Preservation Department – Item 1, LPC-23-08657

**346 Broadway (aka 108 Leonard Street, 46 Lafayette Street) – Former  
New York Life Insurance Building – Individual and Interior Landmark  
Borough of Manhattan**

# DESIGN REVISIONS

## IN RESPONSE TO COMMISSIONER COMMENTS

## CEILING

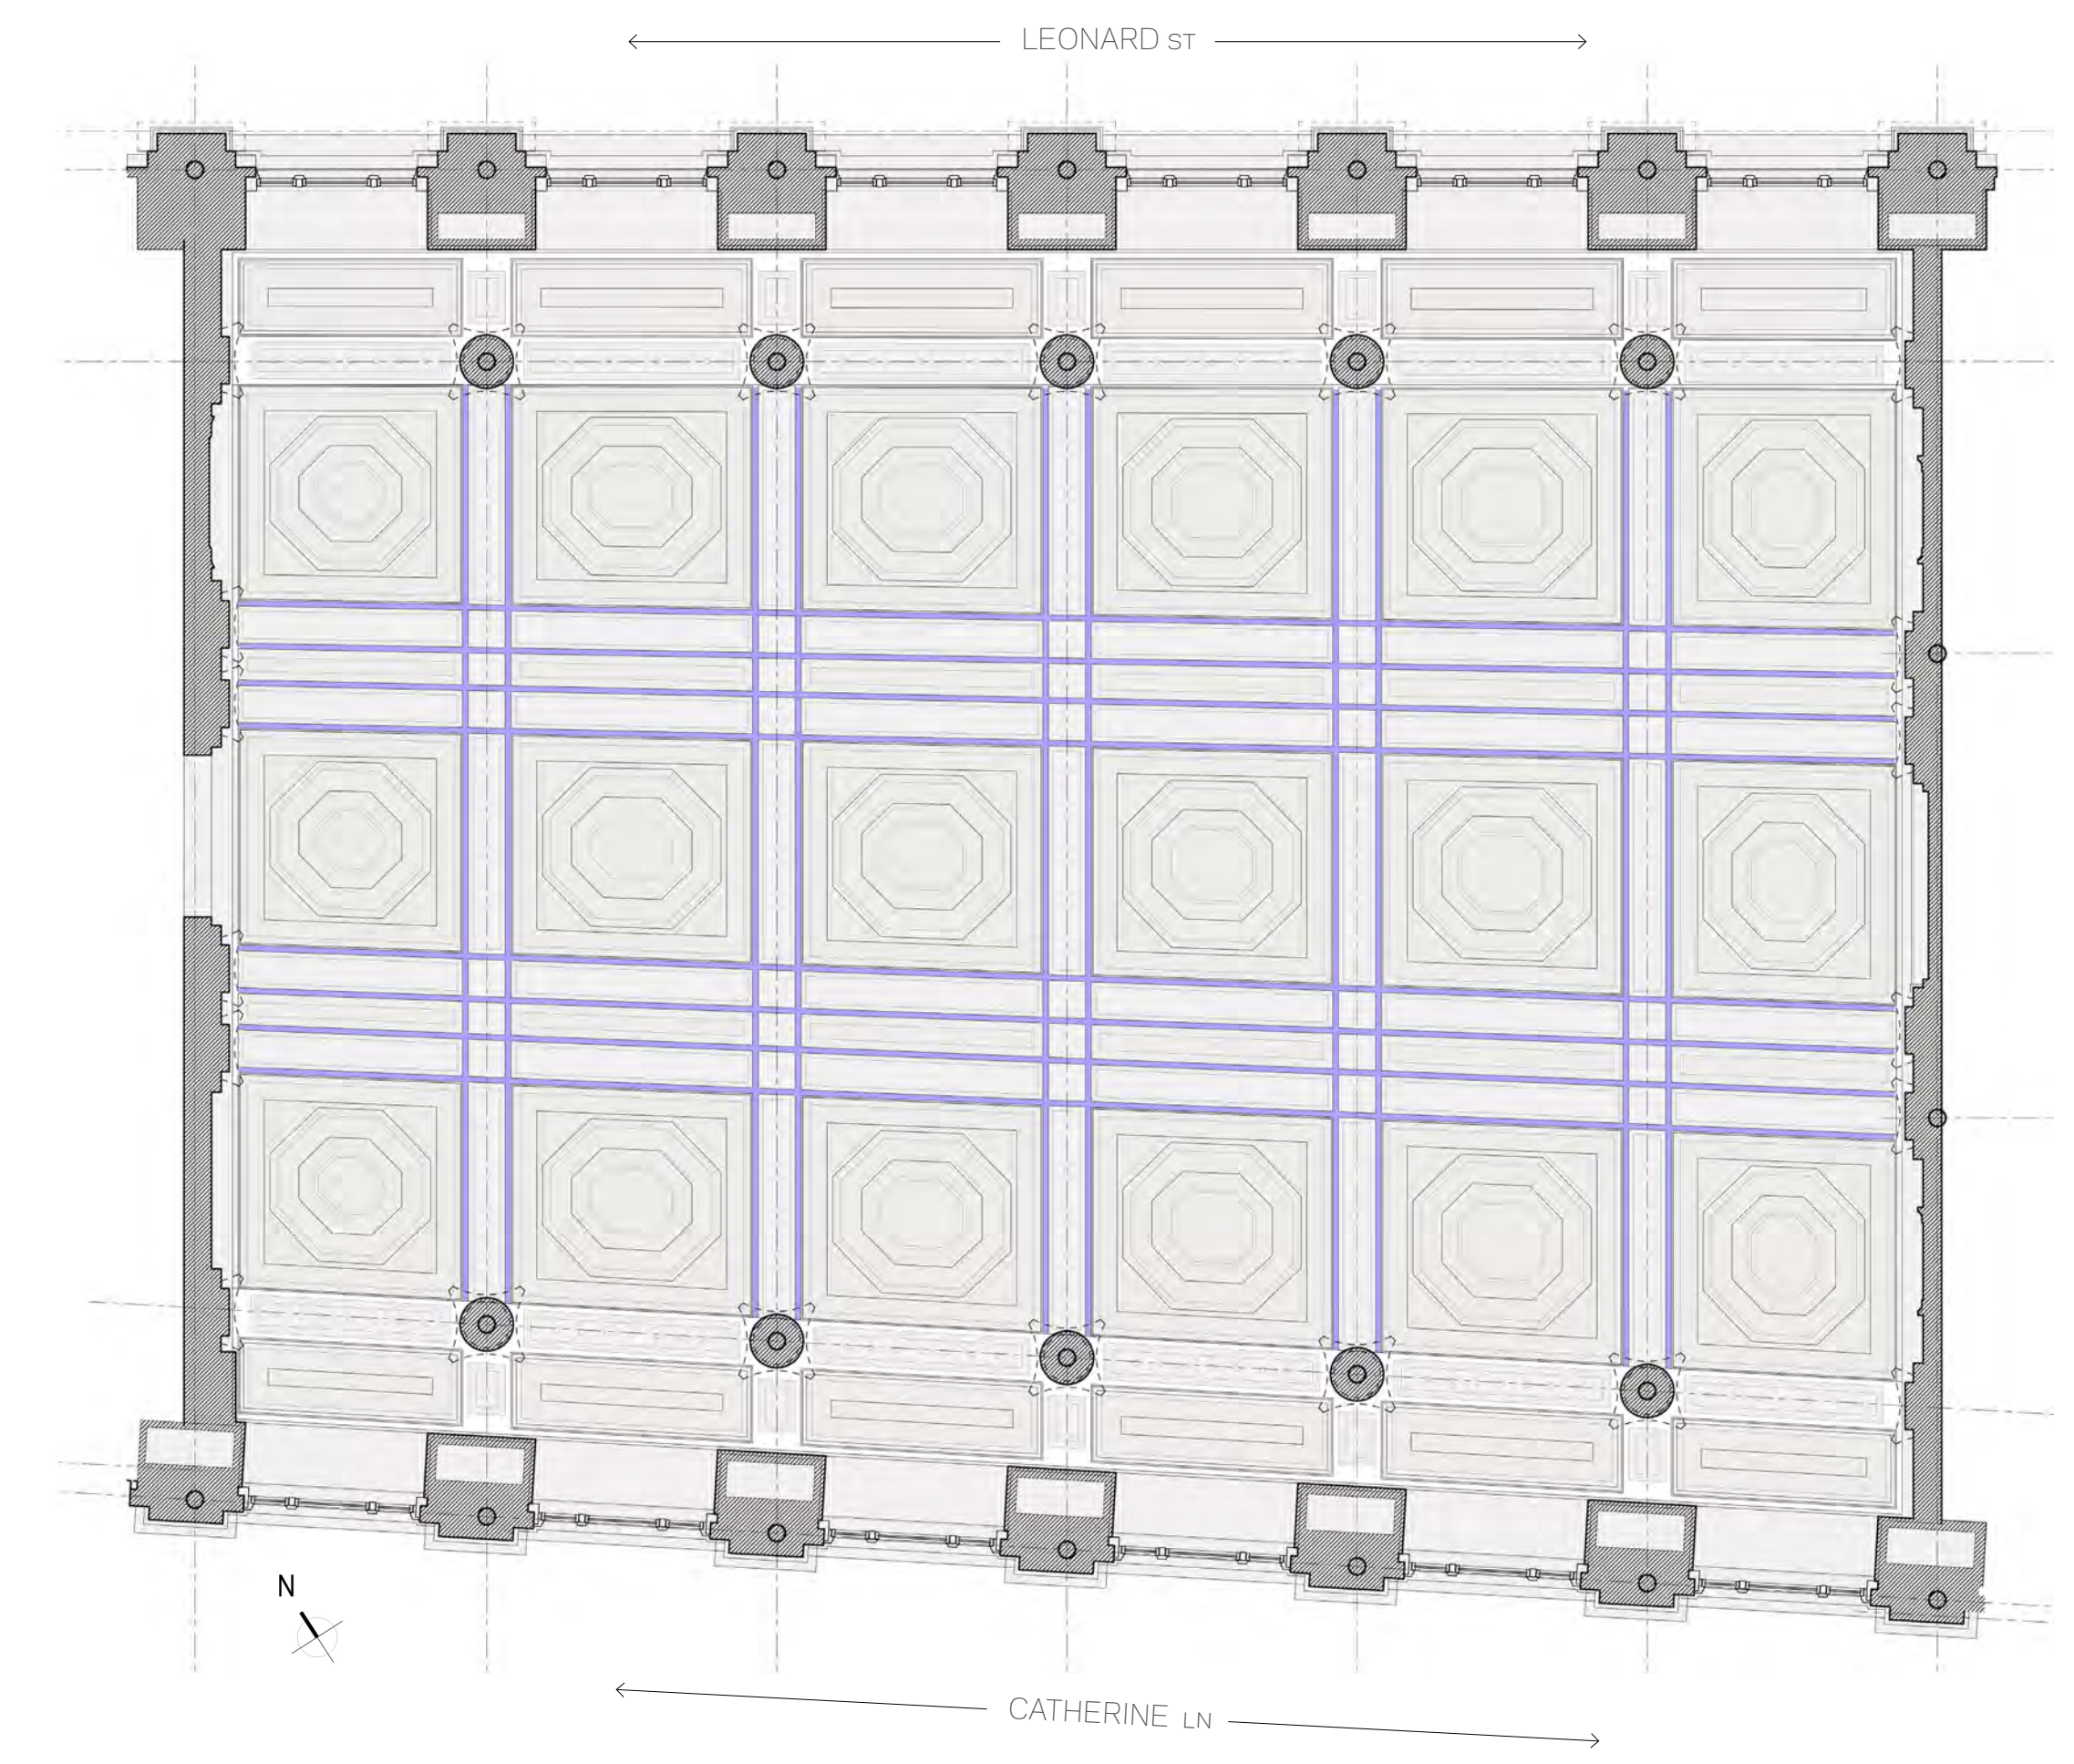
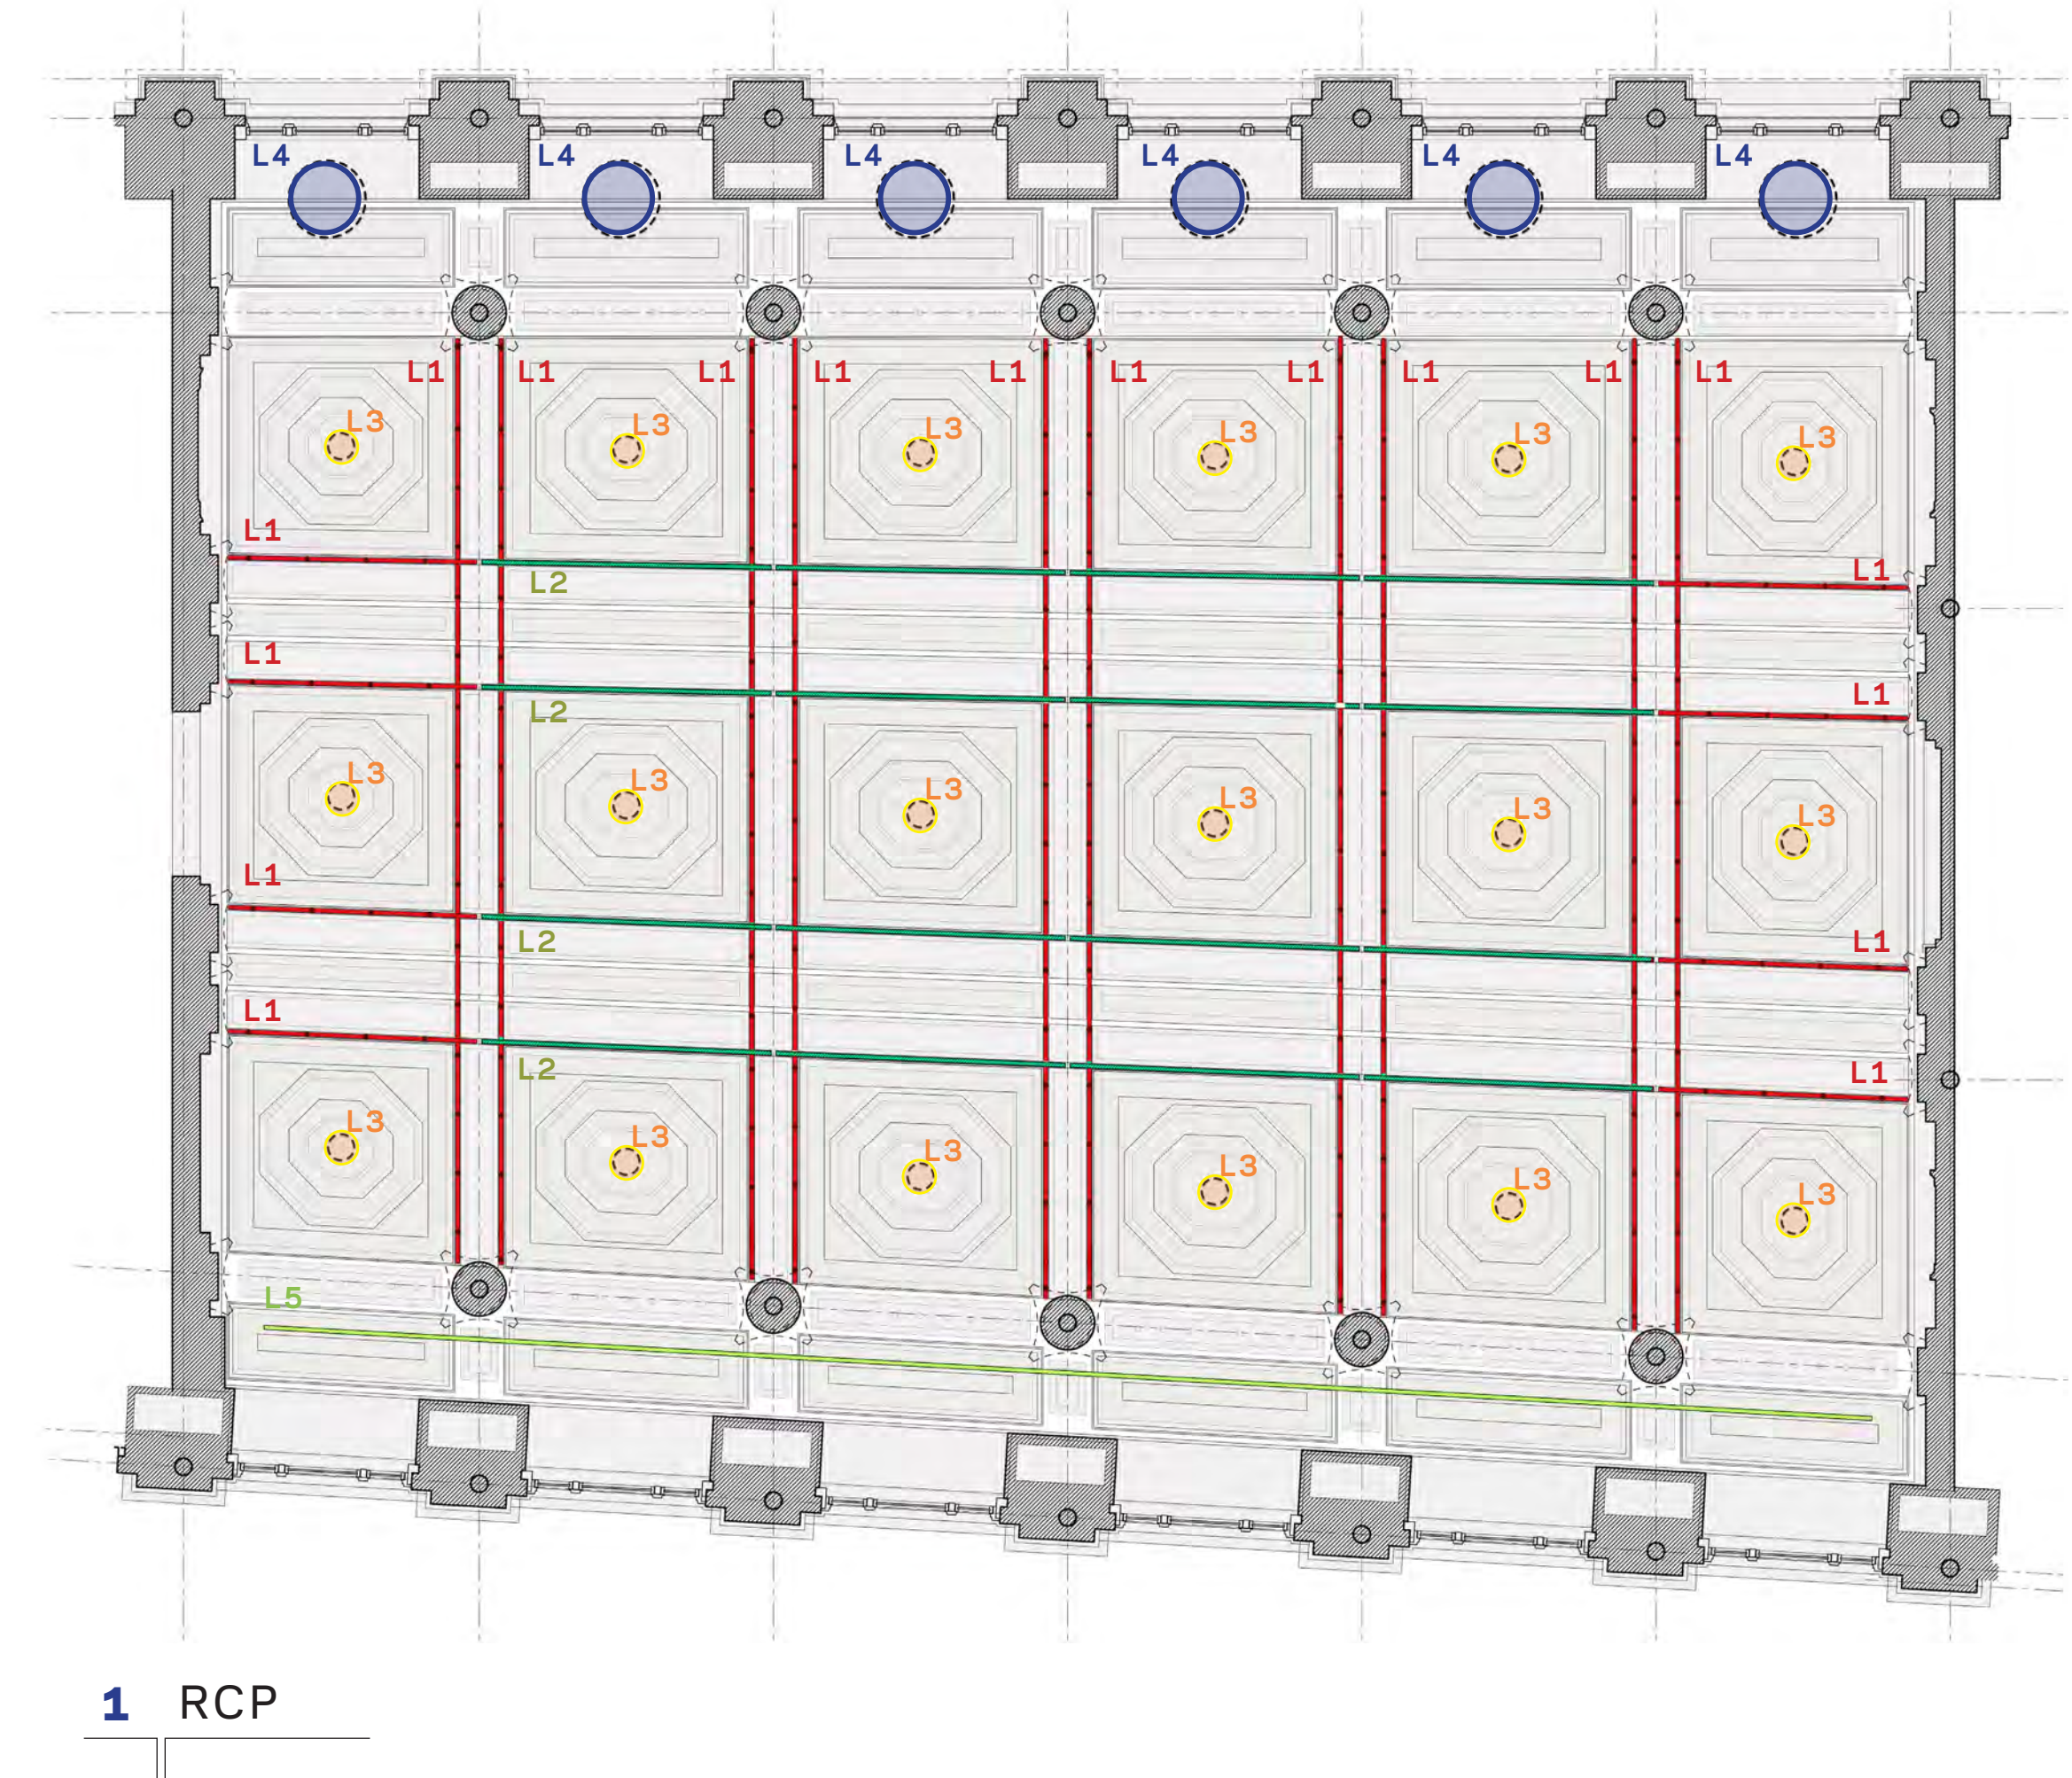
The lighting design has been revised to create a continuous system along the existing grid of the historic ceiling, which is articulated in flat plaster. This system is a minimal approach that reinforces the architectural expression of the ceiling and is finished to match the ceiling. The pendant lights, which uplight each coffer, have been raised so as to not break the plane of the grid and will have a dark finish consistent with the rosettes that originally occupied the coffers.

The lighting design will maintain and reinforce the existing pattern of intersecting straight lines.
